#### Landscape work issues (not a comprehensive list)

# Failed shrub plantings

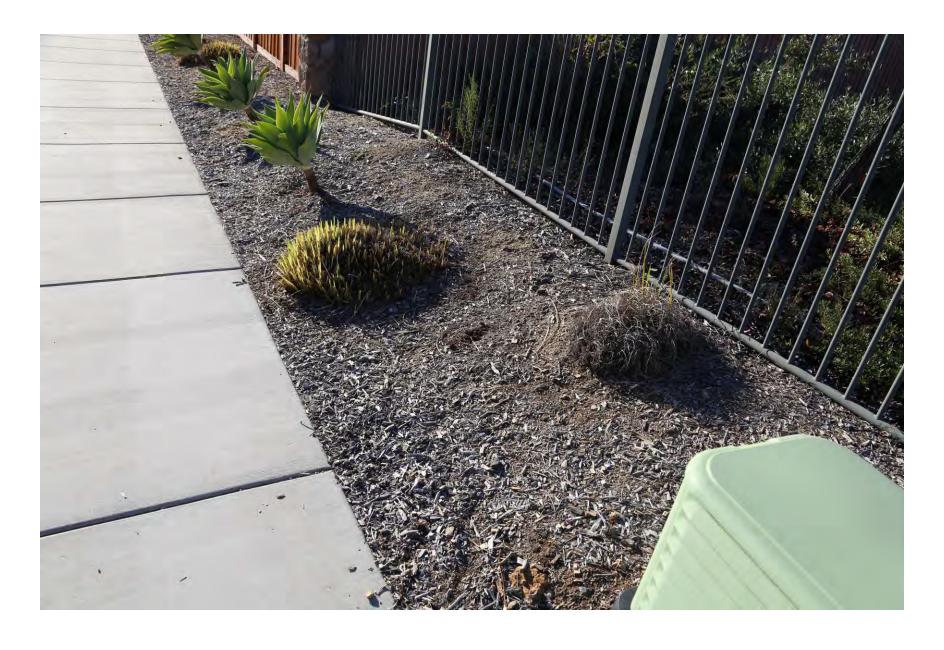
Exposed ground, sprinkler to nowhere, shrub gone

Existing plants dying through neglect, replace with Agave, resulting in inconsistent appearance.

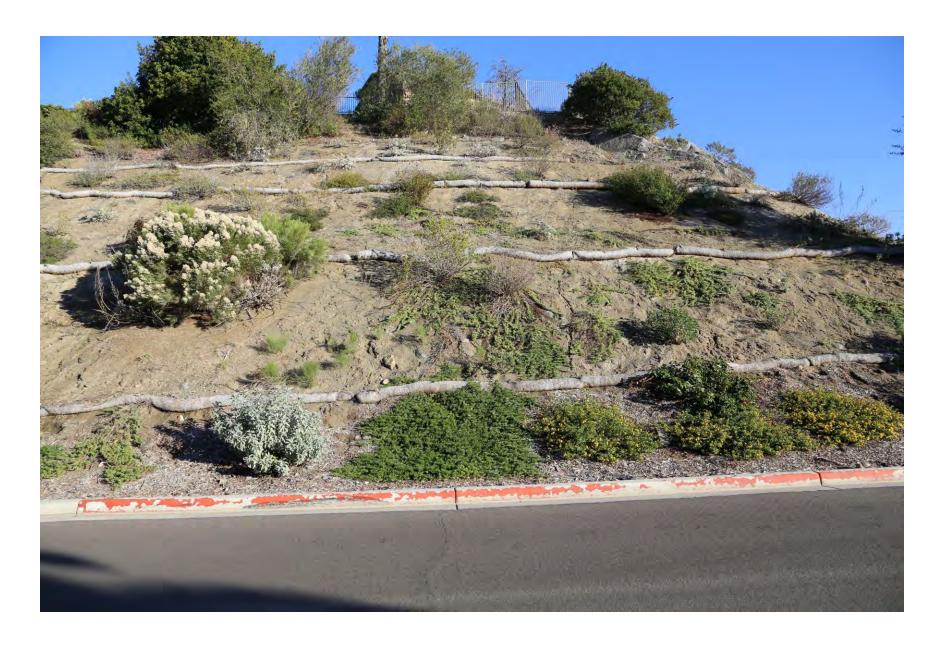
Exposed ground, erosion

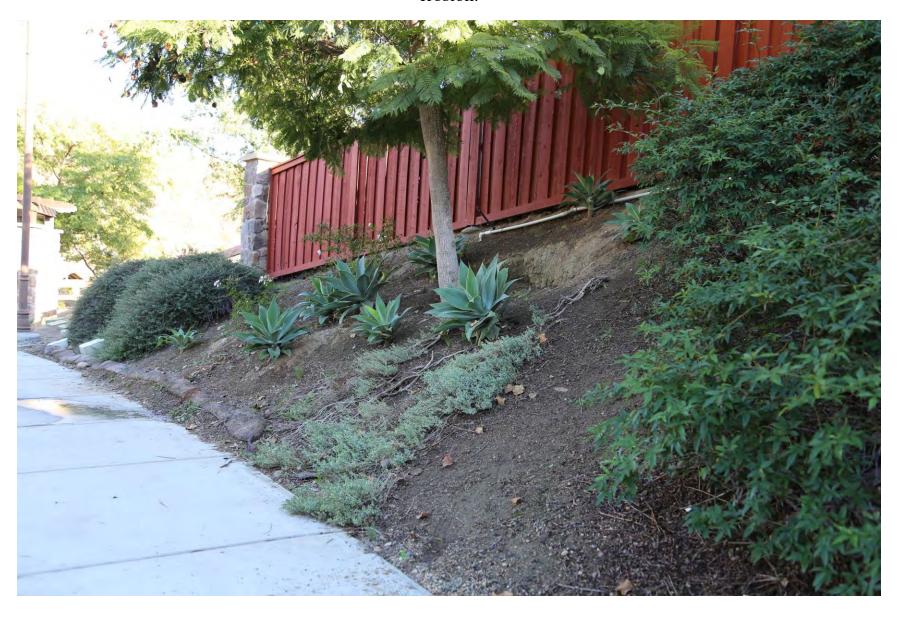
Homeowner destroyed landscape when installing pool. Green bushes to the right and left weren't used to fill the gap, now it is a soggy inconsistent mess, and erosion.

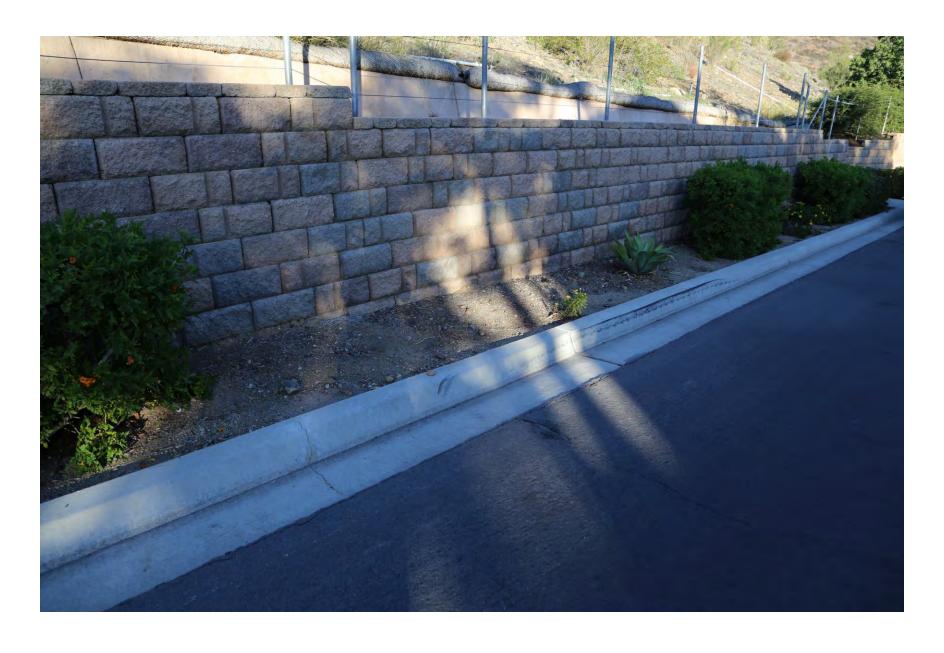
Exposed ground, large gaps in palate, Agave fix begins

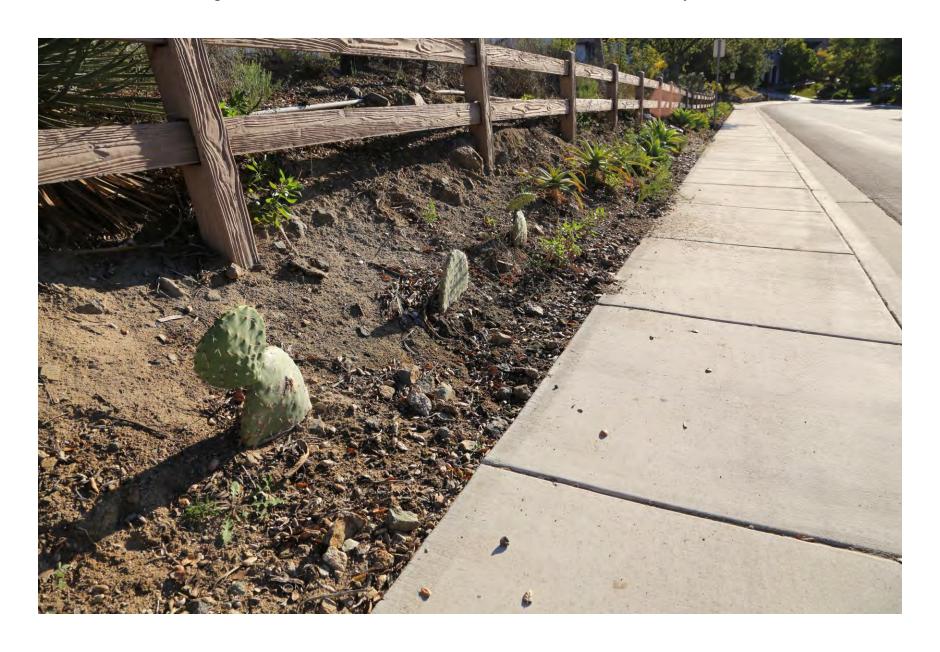
Agave fix. Installed Cactus next to the sidewalk which is a safety issue.

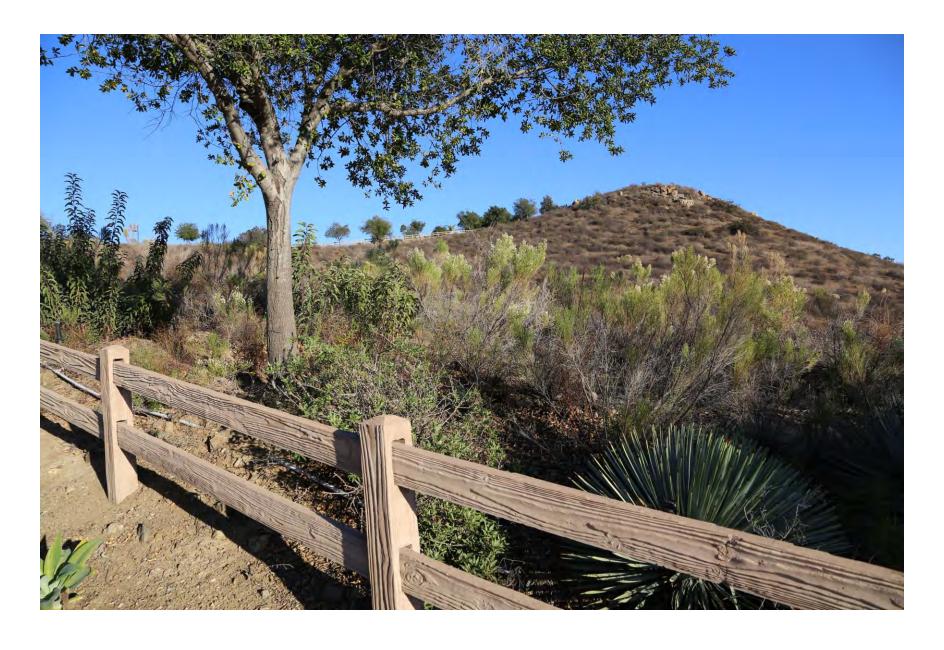
Not maintained to FMZ requirements. Large Sumac, Desert Broom and other plants not trimmed or thinned. Too much of the area is native per FMZ code.

Mass of vegetation in FMZ / Next to Fire Apparatus Road.
Plants should not form masses anywhere.

# Exposed ground

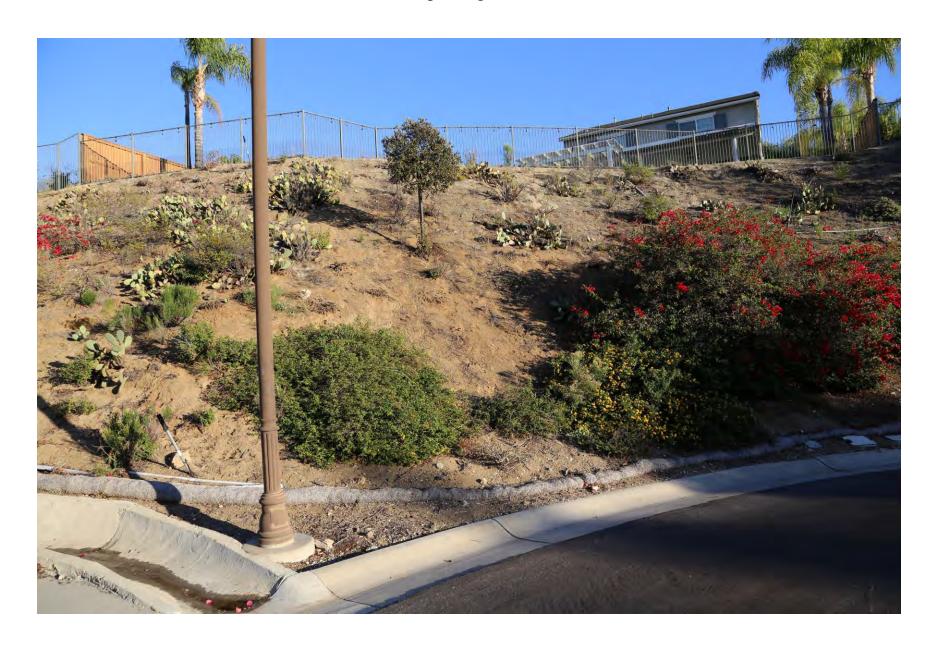
Native plants including Desert Broom have taken over; untrimmed; massed together; fence not cleared 18"

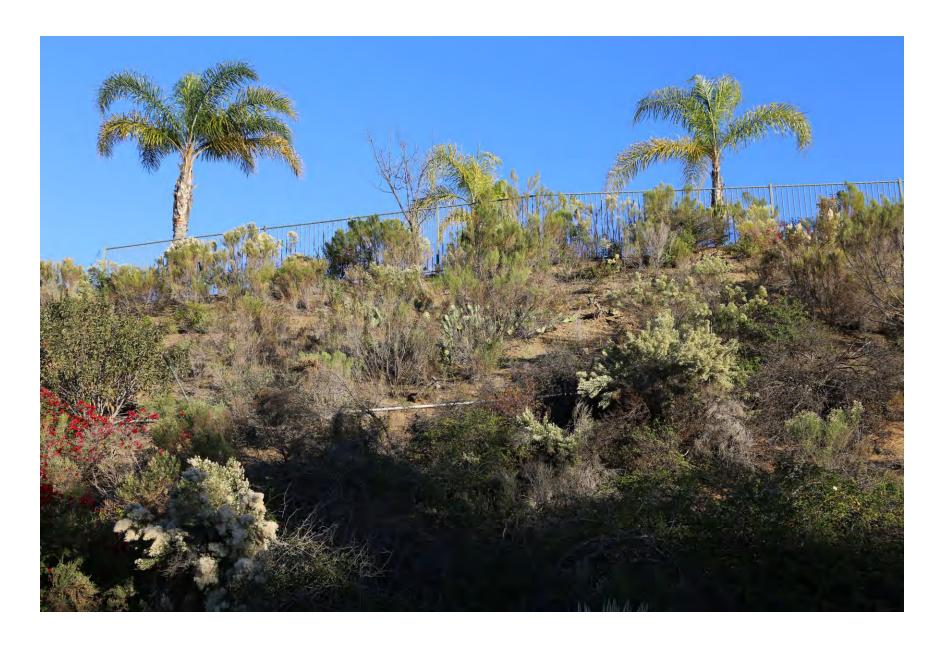
Rebar is protruding from straw wattle in many parts of the community Erosion
